DEPARTMENT OF HIGHWAYS AND PUBLIC TRANSPORTATION

MEMORANDUM TO DESIGN GROUP LEADERS & CONSULTANTS

Subject: Slab Coping at Top Flange of Steel Beams and Girders

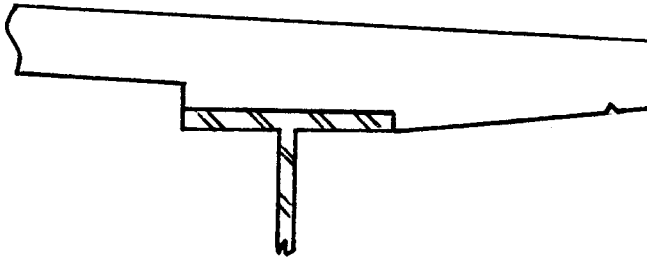
It has been the Department's practice to detail a 4 inch projection of the slab build-down past the edges of the top flange of steel beams and girders. This detail is routinely eliminated when metal or concrete deck forms are used on a project.

On projects not already detailed, this 4 inch projection should be eliminated and the build-down detailed flush with the edge of the beam flange as shown below. The cantilevered slab and build-down at the exterior beams shall continue to be detailed in accordance with current practice.
